Commonwealth Edison Company

August 31, 1971

Subject: Proposed Change No. 14 to Appendix A,
DPR-19, AEC Dkt 50-237

TRANSIENT ANALYSES OF PROPOSED TESTS FOR WHICH A TEMPORARY WAIVER OF FLOW
REFERENCED SCRAM IS REQUESTED AND A FIXED 120% APRM FLUX SCRAM IS PROVIDED

Fig 2C-2

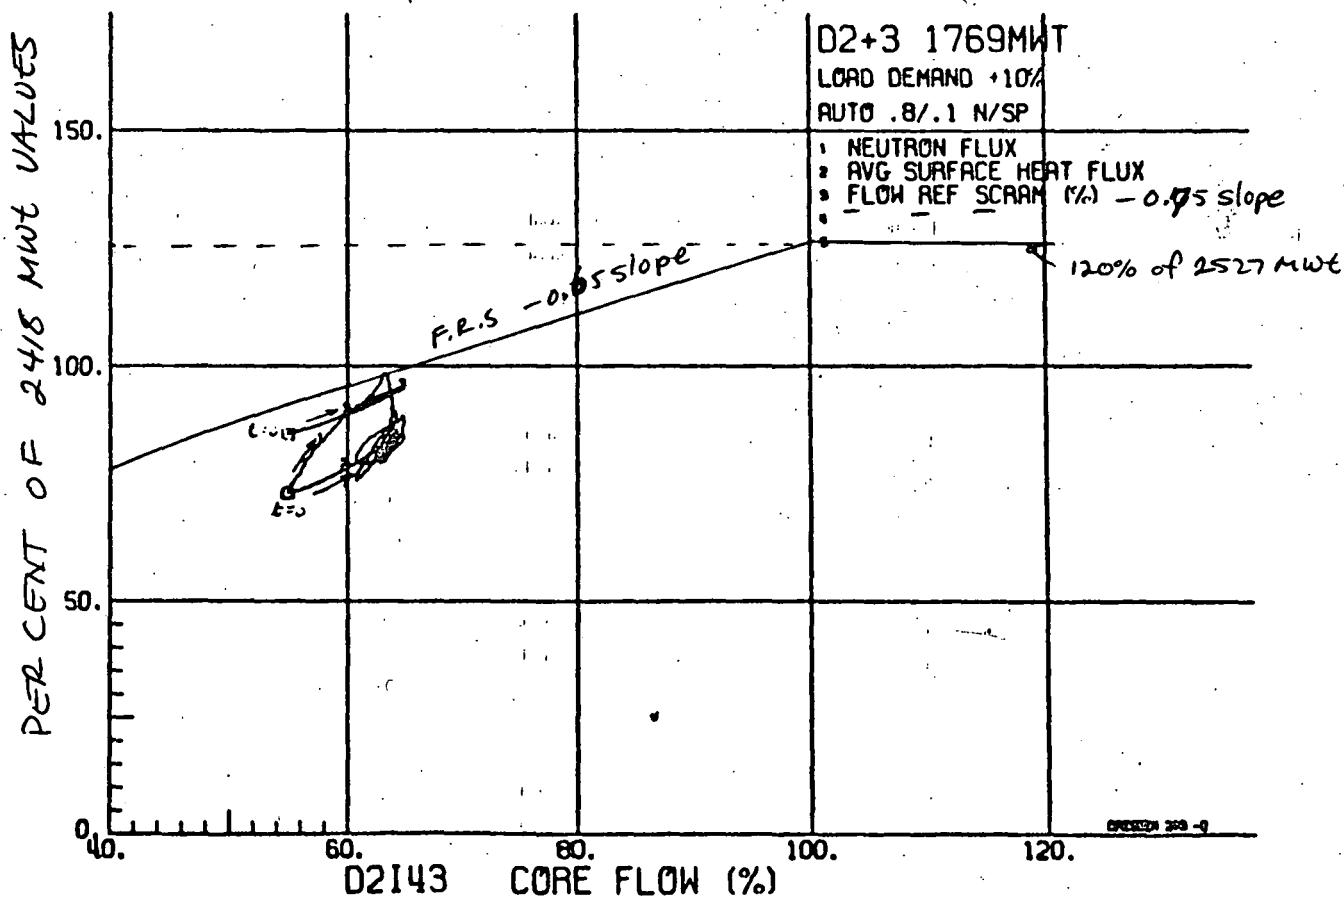
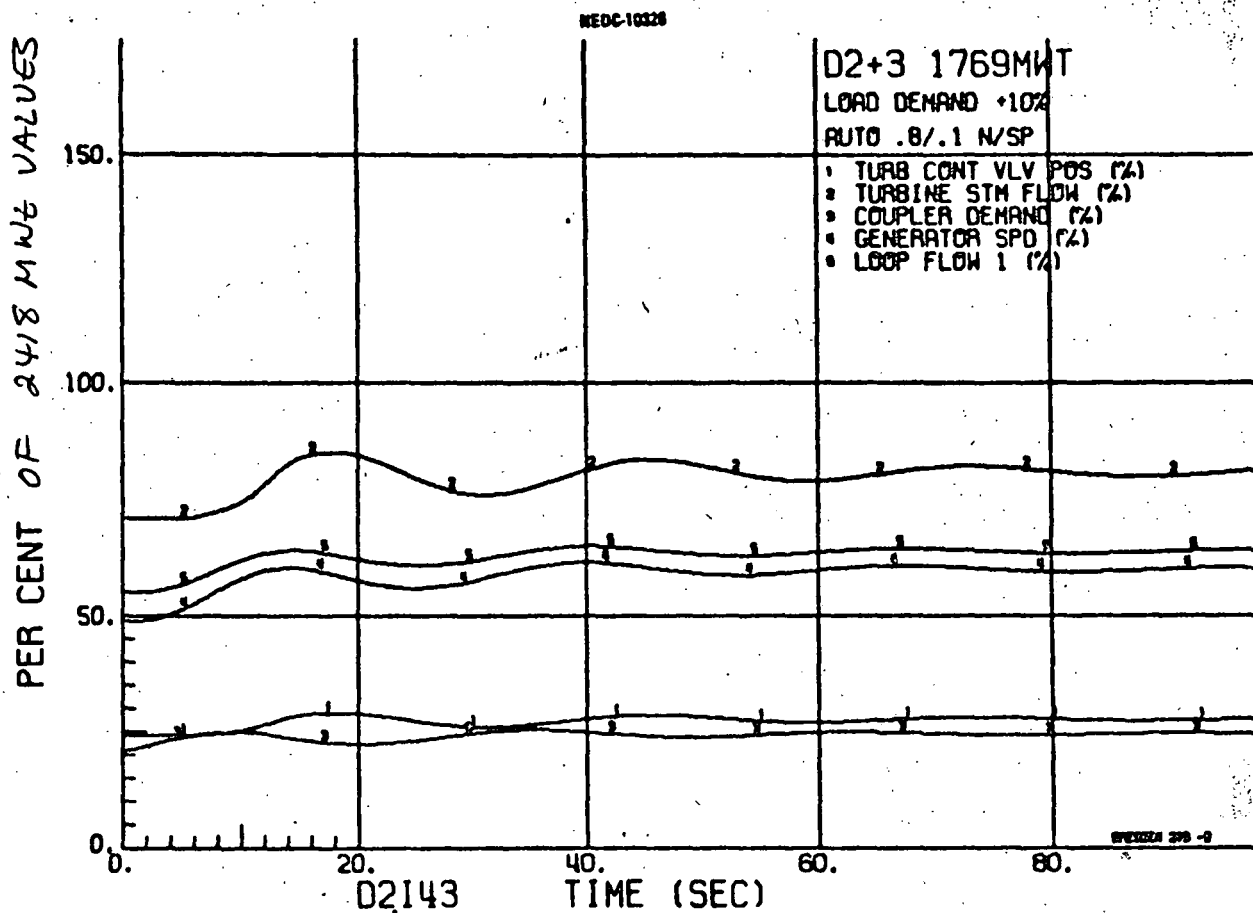
Figures 2C-1 and 2C-2 show the expected response without transient setpoint adjuster with both proportional gain and reset gain of the Master Flow Controller at the expected optimum values. Note that interference by flow referenced scram is predicted by this analysis. This analysis is also significant as it shows the response of the plant for the case of a failure of the transient setpoint adjuster in an "as is" failure mode. Plant response is sufficiently damped such that if such a failure should occur while the plant is operating in the automatic flow control mode, the operator can easily transfer to the manual mode of operation. The final settings of the Master Flow Controller will be such that the decay ratio of the response will 1/2 or lower without a transient setpoint adjuster as shown in the analysis.

Fig 2 D-1

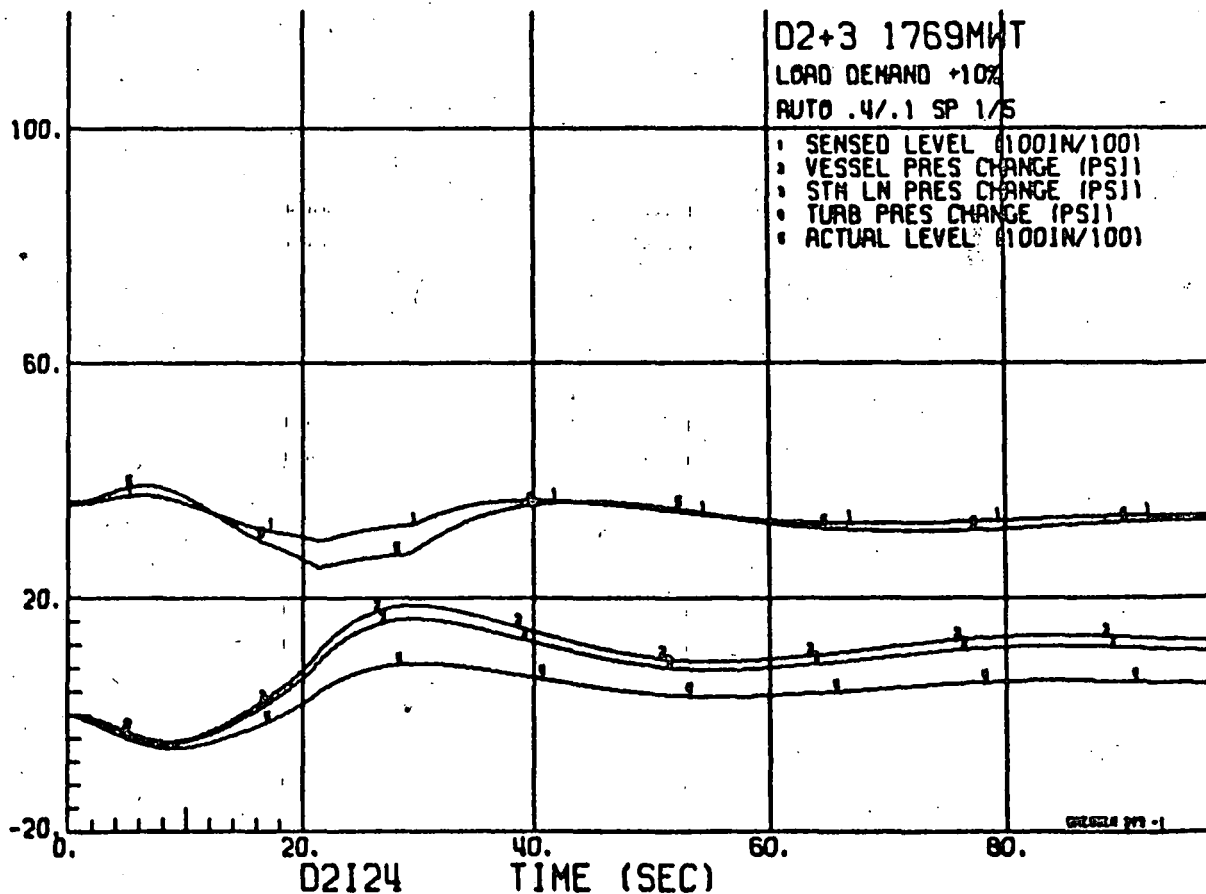
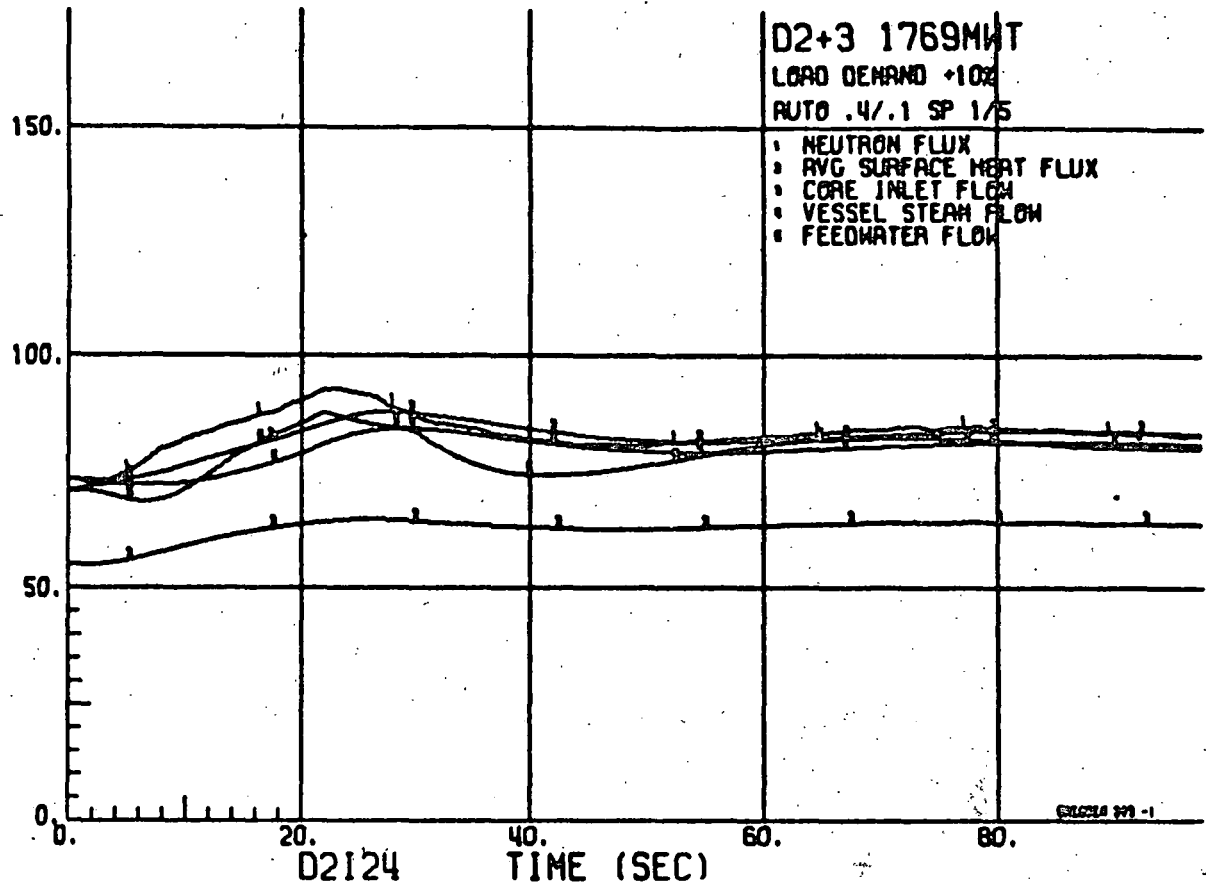
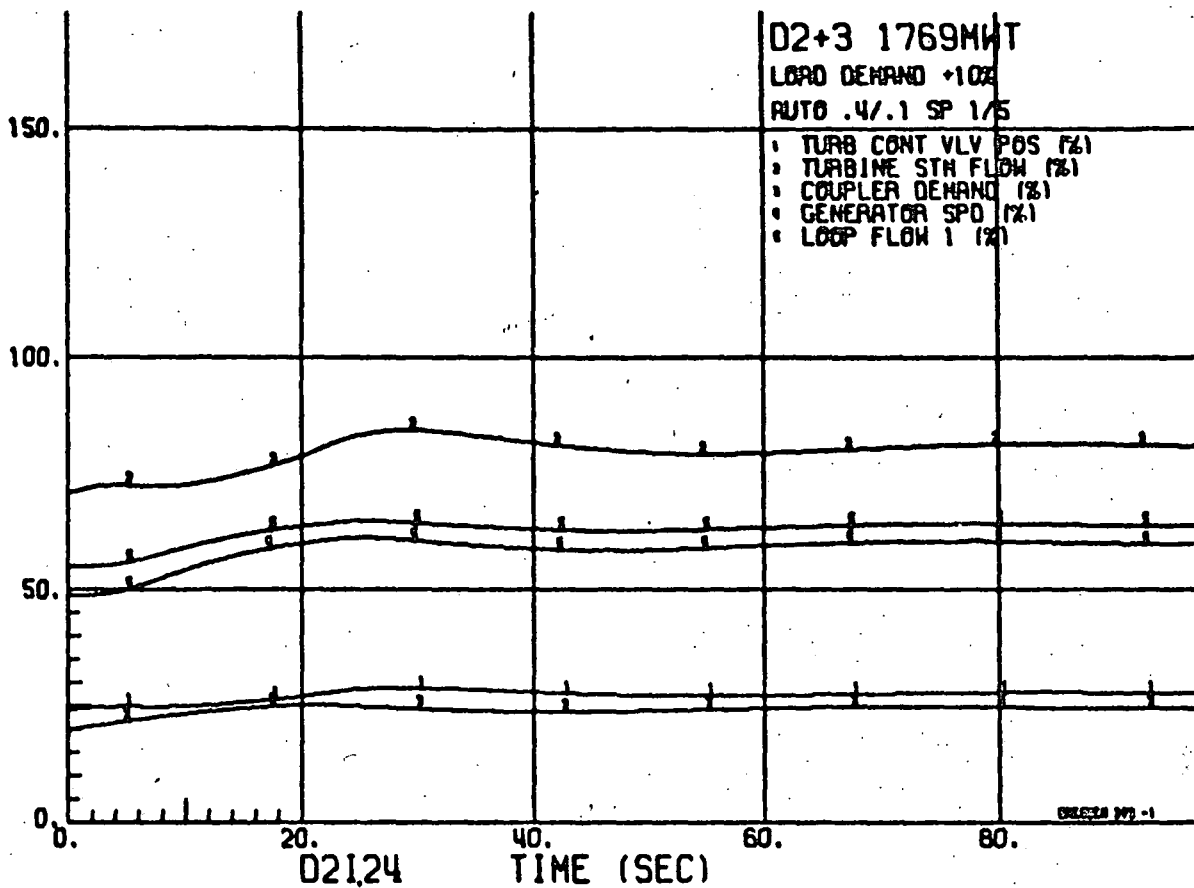
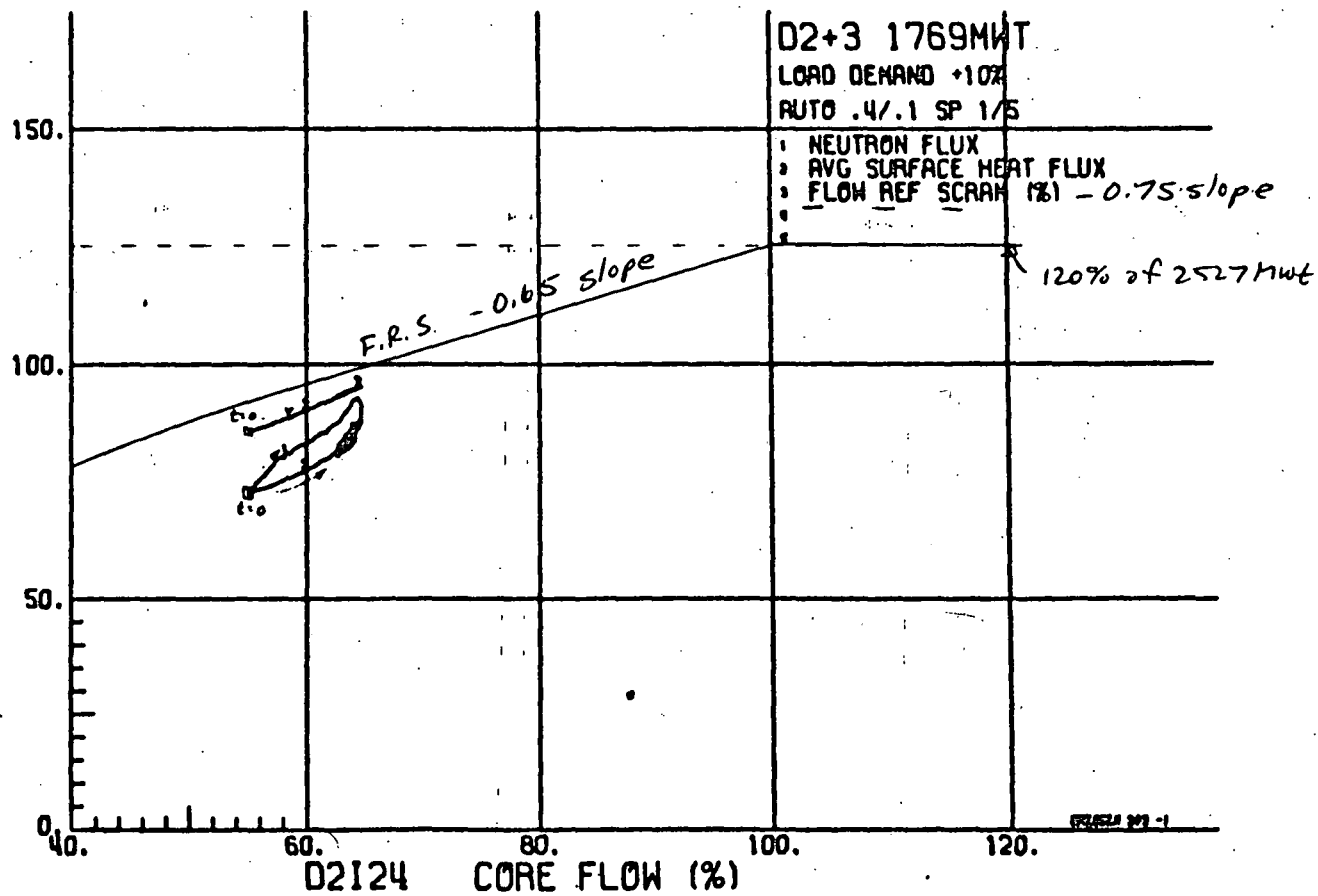
Prior to placing the transient setpoint adjuster into service, the proportional gain of the Master Flow Controller will be reduced to 1/2 of the expected optimum value. Tests will then be performed while bringing the settings of gain and time constant of the transient setpoint adjuster to their expected optimum values. Figures 2D-1 and 2D-2 show the response of the plant to a 10% load demand increase step with near optimum settings of the transient setpoint adjuster, and with master flow controller reset gain at expected optimum value and proportional gain at 1/2 of expected optimum value.

Fig 2E-1

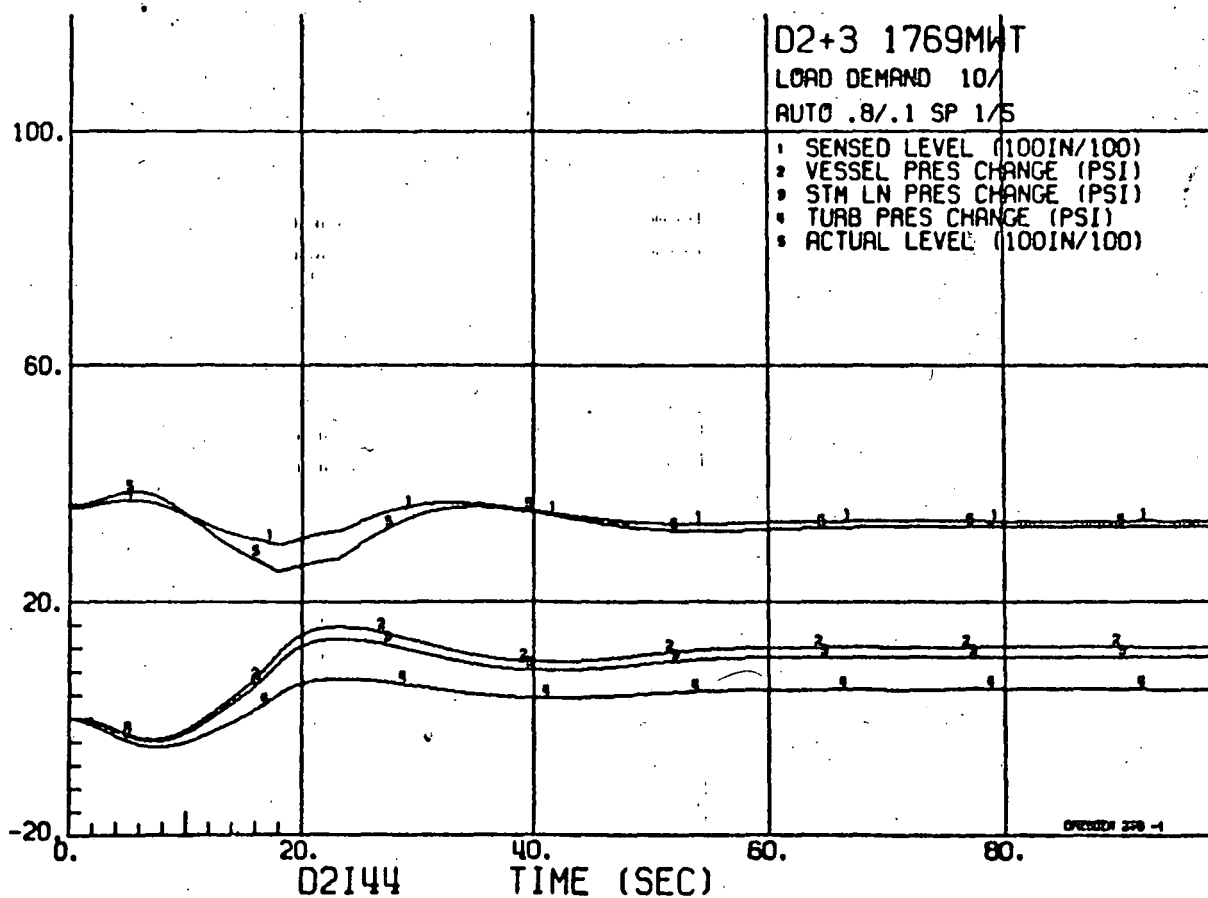
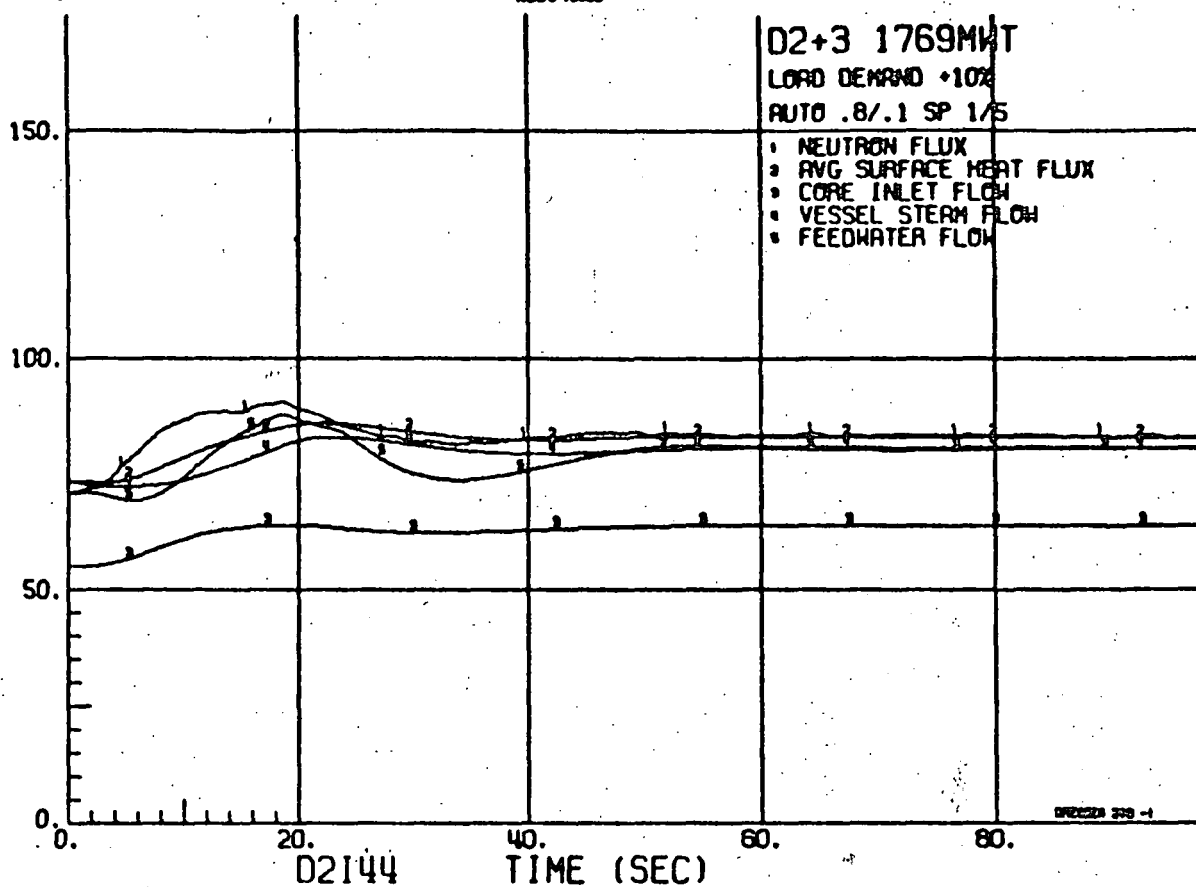
Figures 2E-1 and 2E-2 show the expected response to a 10% load demand step increase with the settings of both the master flow controller and the transient setpoint adjuster at the expected optimum values. On the top plots of Figure 2E-2, note that the turbine steamflow response, (the parameter being optimized in these tests), is such that the 10% increase is reached within the desired 20 seconds.
